MODELLI / MODELS : KM010 / KM011 / KM013 / KM030 / KM036 / KM502 / KMC010 / KMC030

**OGGETTO:
SUBJECT : Gearbox / Planet Hub modifications**

MONTH (IT) / MARCH (UK) 2013

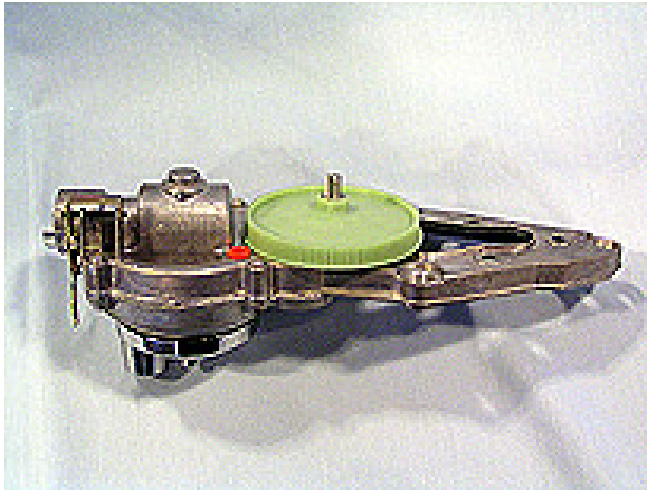
From date code 13T05 a change has been made to the planet hub and gearbox for the above models.

Due to an increase in the number of customer with reported tool jams, the planet hub has been modified to expose the bayonet fixing more and make it easier for the customer to locate the tool they are using.

Old Planet Hub KW711656

New Planet Hub KW715264

The new planet hub CAN be retrofit to older machines without the need to change the pre-existing gearbox.
